**OTAY MESA CENTRAL VILLAGE  
SPECIFIC PLAN  
SAN DIEGO, CALIFORNIA**

Subject: 3rd UPDATE LETTER  
OTAY MESA CENTRAL VILLAGE SPECIFIC PLAN  
SAN DIEGO, CALIFORNIA

Subject: OTAY MESA CENTRAL VILLAGE SPECIFIC PLAN  
SAN DIEGO, CALIFORNIA

Subject: 2<sup>nd</sup> RESPONSE TO CITY OF SAN DIEGO REVIEW COMMENTS  
OTAY MESA CENTRAL VILLAGE SPECIFIC PLAN  
SAN DIEGO, CALIFORNIA

**GEOLOGIC MAP**  
 OTAY MESA CENTRAL VILLAGE  
 SAN DIEGO, CALIFORNIA

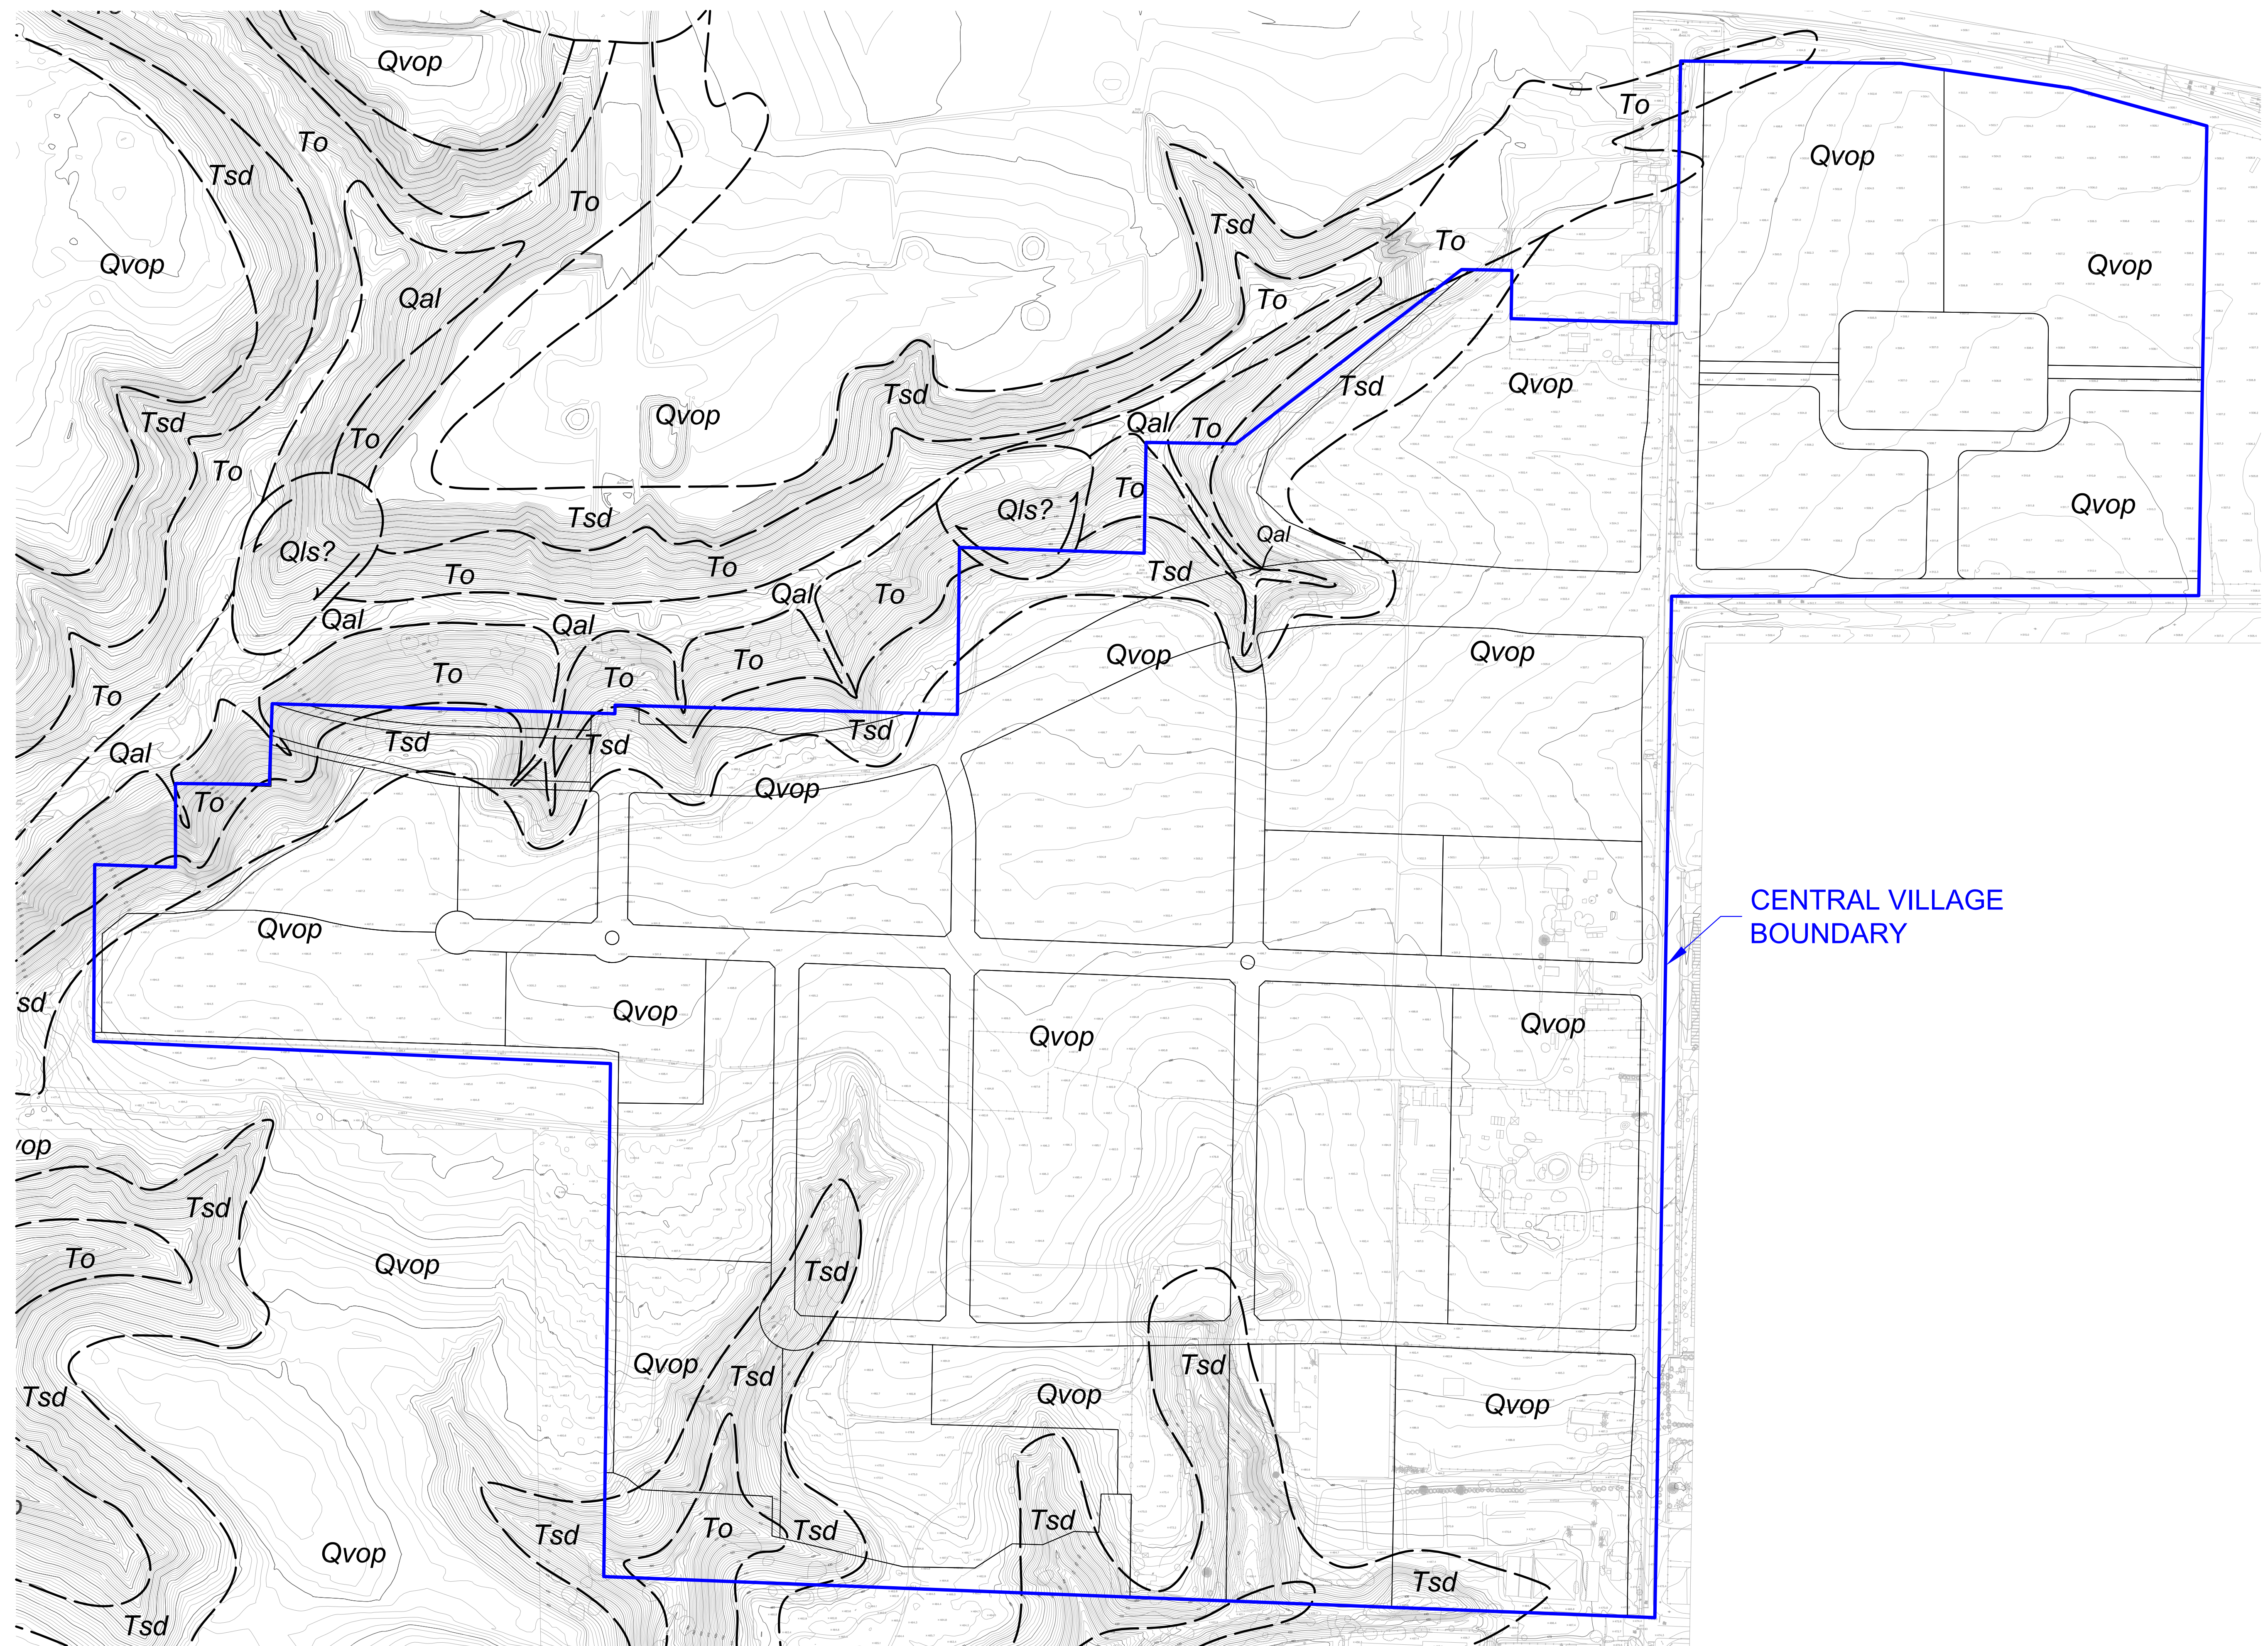
**Issue 4:** *Provide a geologic/geotechnical map of the Central Village Specific Plan area:*

**Issue 5:** *Address the potential for slope instability within or adjacent to the plan area, associated impacts, and potential mitigation measures.*

**Response:** The map is provided herein as Figure 1 (Geologic Map) and Figure 2 (Land Use Plan).

**Response:** Two landslides are mapped in the vicinity of the Central Village Boundary. Both are located within the canyon drainage area on the north side of the property (see Figure 1). The head of one of the landslides is mapped within the open space area

of PA 15 (see Figure 2). This suspected landslide does not pose a risk to the planned development as it is adjacent to land designated as open space. The risk associated with ground movement hazard due to landsliding is low.

Landslides shown on Figures 1 and 2 are based on published sources or inferred using topography. The shallow, suspected landslides are based on reconnaissance mapping conducted for this report or the City of San Diego Seismic Safety Study (2008) and are not verified by subsurface exploration. As such, the mapped expression of suspected landslides may not be relied upon as definitive of their existence.

GEOLOGIC MAP

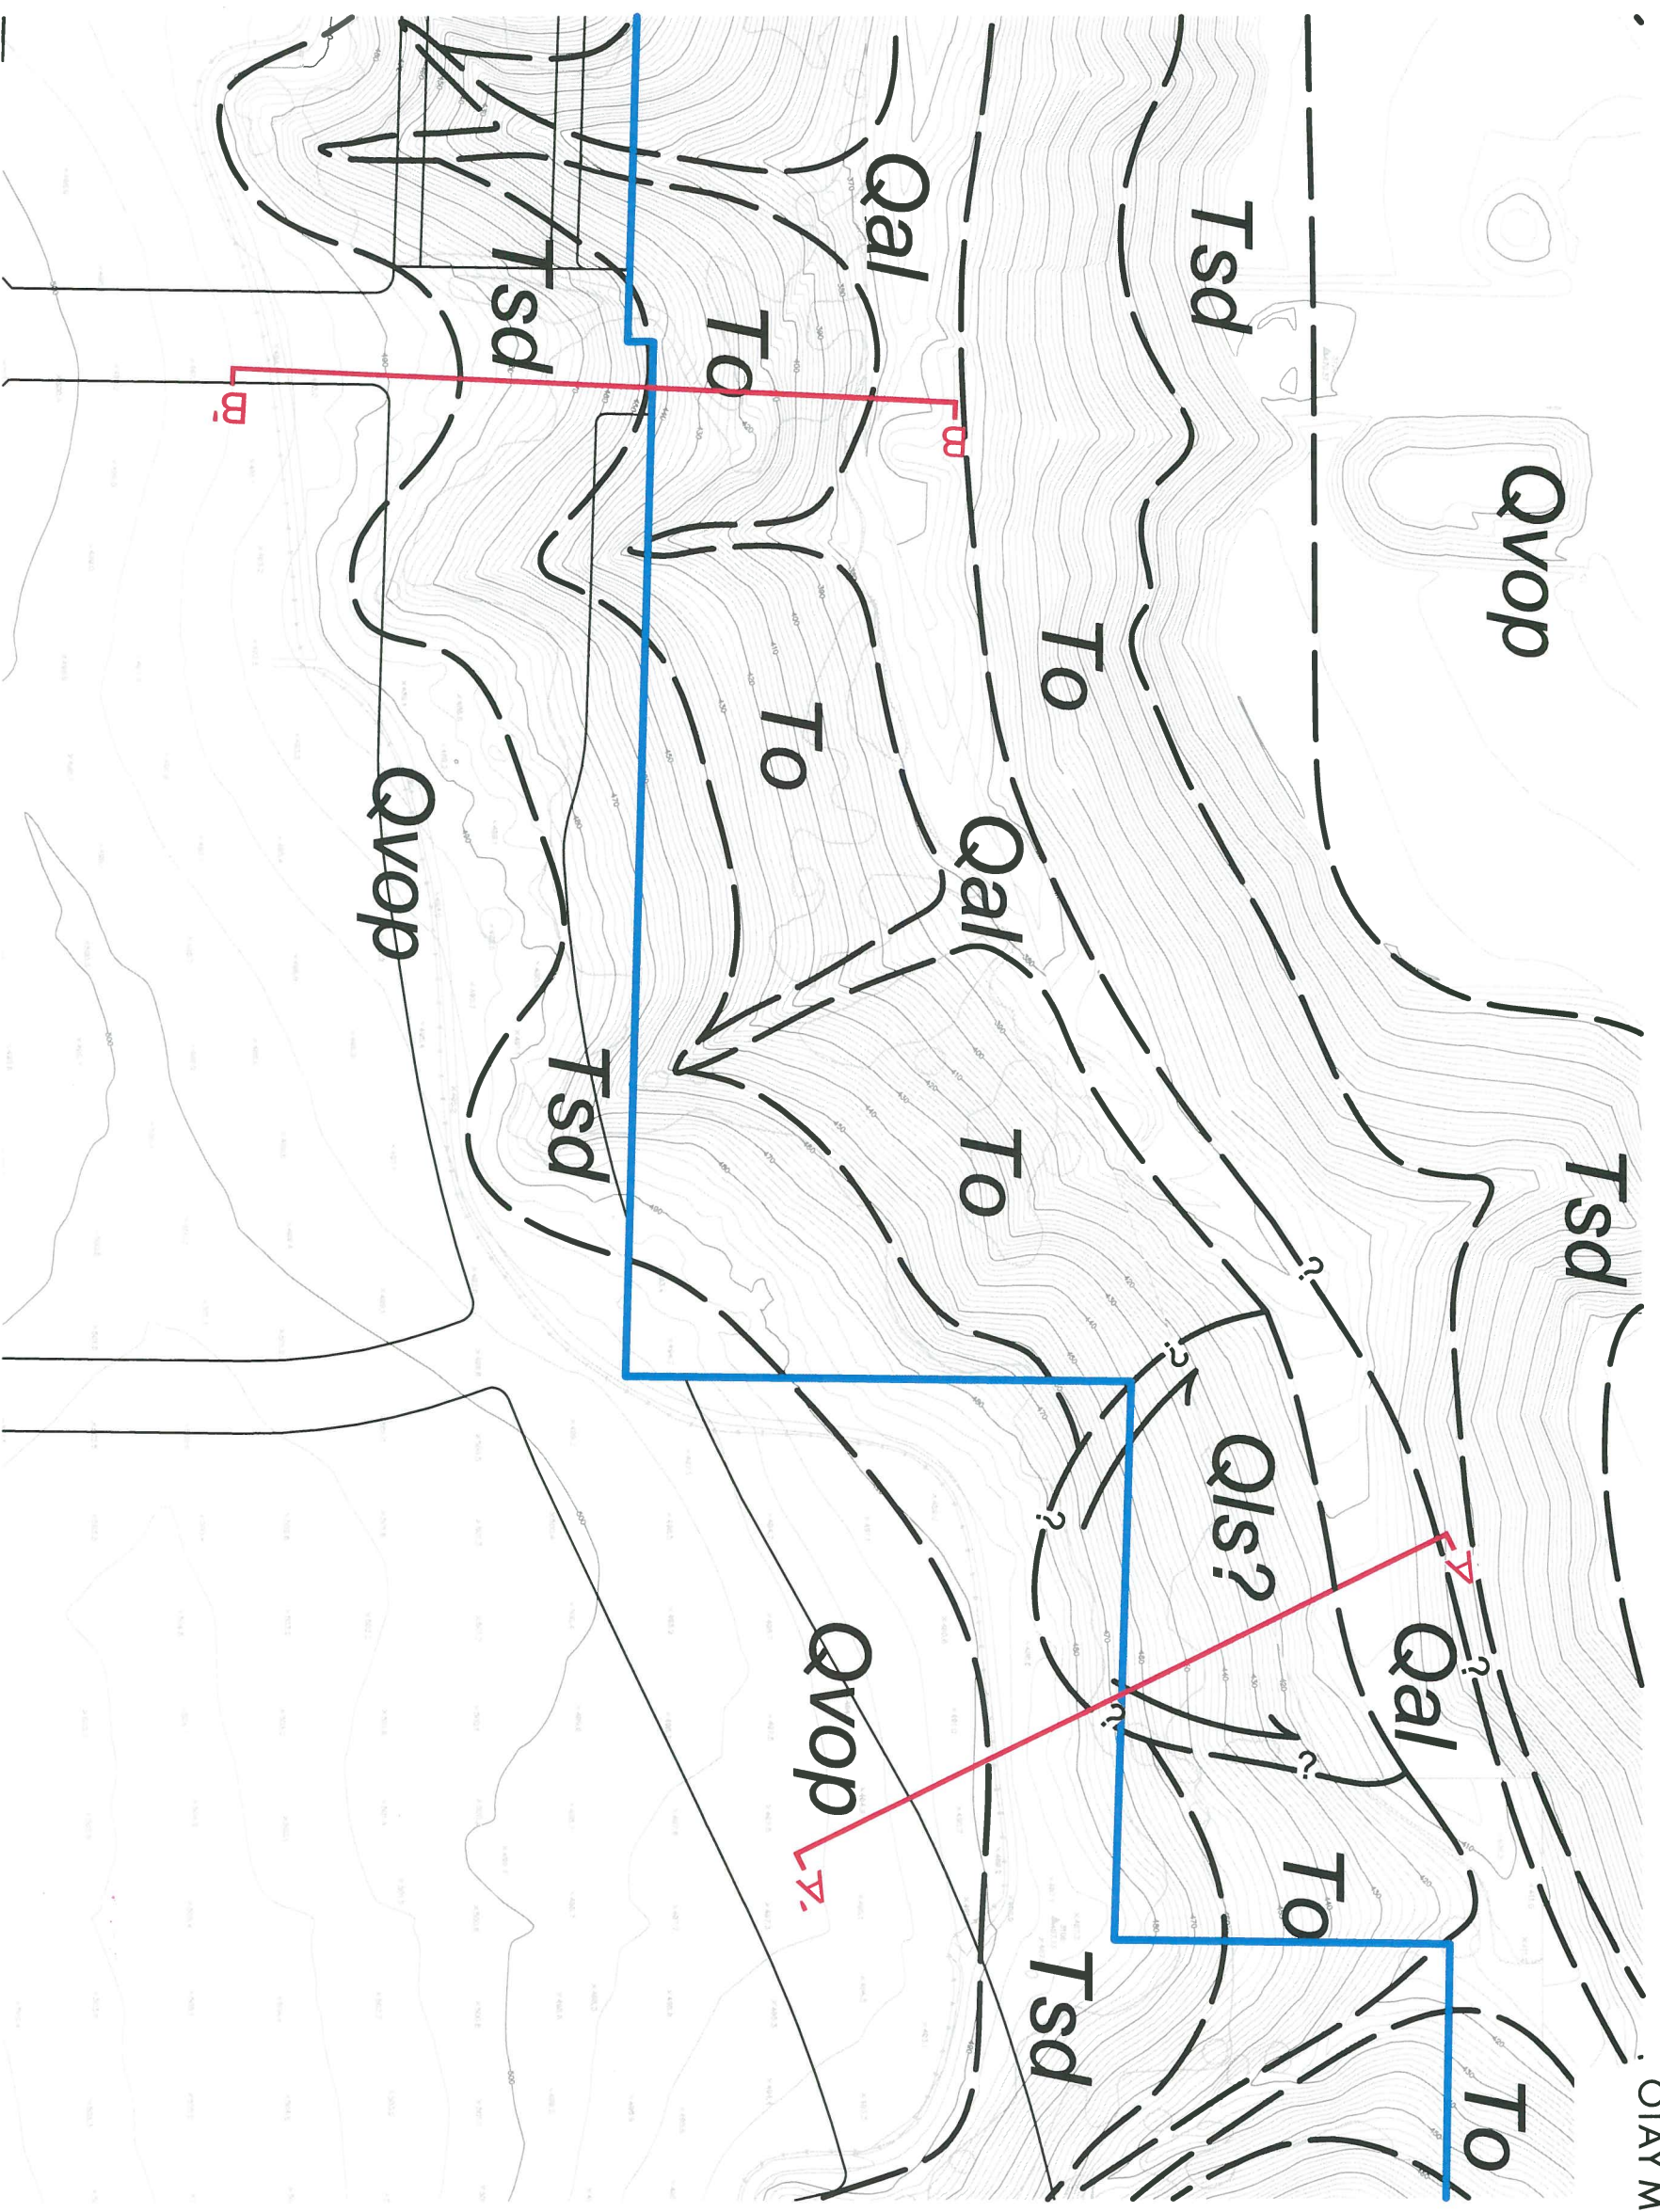
**Issue 17:** *In their response to comments date October 3, 2016 [Reference 2], the project's geotechnical consultant opines that the risk associated with landslide hazard of the Otay Central Village Specific Plan [Reference 3] is low. However, the geologic map included in their report dated October 9, 2012 [Reference 4] indicates that landslides are suspected along the canyon slope in the northern portion of the of the Specific Plan area. The project's geotechnical consultant should indicate if slope stabilization will be necessary to support the improvements.*

**Issue 19:** *If stabilization of the slope supporting the planned extension of Airway Road is necessary, identify the approximate limits of grading for the purpose of analyzing the impacts to environmentally sensitive lands.*

**Response:** We have performed a site reconnaissance and reviewed aerial photographs specific to the proposed alignment of the Airway Road extension, as shown in Reference 3. Based on this review, it is our opinion that there is not convincing evidence to confirm

the presence of the conjectured landslide shown on Figure No. 1. It is also our opinion that, if this conjectured feature is present, its closest horizontal proximity to the proposed roadway is at least 150 feet and the likelihood of the slide impacting the proposed roadway in this area is low. It is our opinion that slope stabilization should not be required to support the proposed roadway improvements.

**Response:** We don't anticipate that stabilization of the slopes supporting the extension of Airway Road as shown on Reference 3 will be necessary. A slope stability analysis was performed assuming conservative geotechnical conditions along Cross Sections A-A' and B-B' (see Figure 1). The analysis considered the natural slope configuration and assumed the presence of a horizontal Bedding Parallel Shear (BPS) daylighting along the toe of the north-facing slope. Strength parameters for the bedrock and BPS materials were selected based on our experience with the geologic units in the area. The stability analysis was performed using Geoslope 2007. A graphic summary of the stability analysis is provided on Figures 2 and 3. The location of the stability cross sections are shown on Figure 1. Based on our analysis, the minimum factor of safety for the overall existing hillside at the two cross section locations is at least 1.5 or greater. The stability analysis should be confirmed once grading plans have been prepared and a geotechnical investigation has been performed.
